Development Application Comment Tracking

APPLICATION TYPE: Plan of Subdivision & Zoning By Law Amendment Application
APPLICATION NO: ZBA12-24-PS1-24-KD
LOCATION: 29 13th Concession Road, Scotland
AGENT / APPLICANT: The Angrish Group
OWNER: Michael Haley
CIRCULATION DATE: April 16, 2025
CIRCULATION TYPE: Third Submission Comments

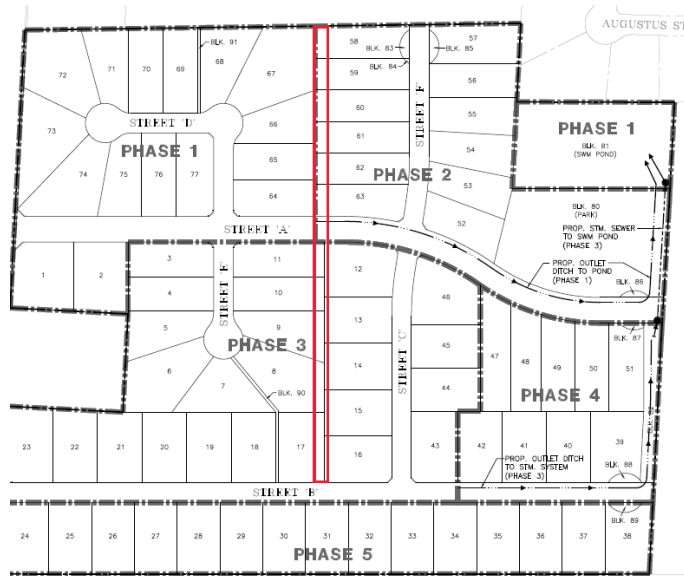
- A **continuous** corridor connecting Street B to the limits of the subdivision to the northeast should be achieved, doing so would create open sightlines from a safety perspective.
- Based on the proposed Plan the most sound configuration for the walkway blocks(s) would be as shown below:
